Access Compliance Report

Public Rights-of-Way (Curb Ramps)

Intersection ID: 3706	Main Street: PROSPERITY_CHURCH_RD	Cross Street: PROSPERITY_POINT_LN	Location:	S
ADA ID: 19BB3288BB4D	Ramp Type: Perp	Initial Pass/Fail: Fail	Overall Compliance: No	Severity Score: 1.25
Codes/Mitigation Info/Possible Solution		Field Measurements/Component Compliance

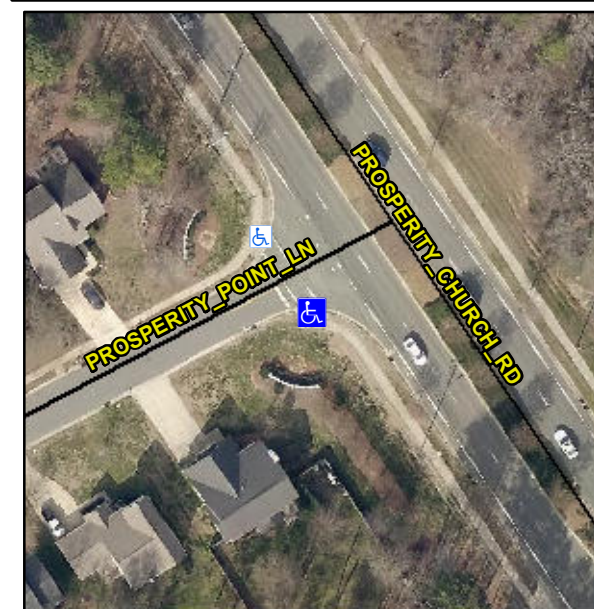
Compliance	Description	Data	Compliance	Description	Data
N/A	Ramp Length (in)	37.5	Yes	Ramp Slope (%)	7.3
Yes	Ramp Width (in)	49.5	No	Ramp XSlope (%)	2.5
N/A	Flare Type LT	N/A	N/A	Flare Type RT	N/A
N/A	Flare Slope LT (%)	N/A	N/A	Flare Slope RT (%)	N/A
N/A	Flare Traversable LT?	N/A	N/A	Flare Traversable RT?	N/A
N/A	Landing Length (in)	N/A	N/A	DWS Provided?	N/A
N/A	Landing Width (in)	N/A	N/A	DWS Contrast?	N/A
N/A	Landing Slope (%)	N/A	N/A	DWS Length (in)	N/A
N/A	Landing X Slope (%)	N/A	N/A	DWS Full Width?	N/A
N/A	Landing Curb? (Y/N)	N/A	N/A	DWS Offset (in)	N/A
N/A	Shared Landing?	N/A			
N/A	Gutter Ponding?	N/A	N/A	Gutter Slope (%)	N/A
N/A	Gutter Lip Ht (in)	N/A	N/A	Gutter X Slope (%)	N/A
N/A	Painted X Walk1?	Yes	N/A	Painted X Walk2?	N/A
	X Walk 1 Direction	To NW		X Walk 2 Direction	N/A
N/A	X Walk 1 Width (in)	95.0	N/A	X Walk 2 Width (in)	N/A
	X Walk 1 Slope (%)	3.0		X Walk 2 Slope (%)	N/A
	X Walk 1 X Slope (%)	2.8		X Walk 2 X Slope (%)	N/A

N/A	Ramp inside XWalk1?	Yes	N/A	Ramp inside XWalk2?	N/A
	Road Slope (%)	N/A	N/A	Clear Space?	N/A
	Road X Slope (%)	N/A	N/A	Clear Space to XWalk (in)	N/A
N/A	Any Obstructions?	N/A	N/A	Storm Grate/Utility Hazard?	N/A
	Obstruction Type			Storm Grate/Utility Type	
		N/A			N/A
		Yes		Surface Condition? (G/P)	Good

Remove & Replace Entire Ramp.
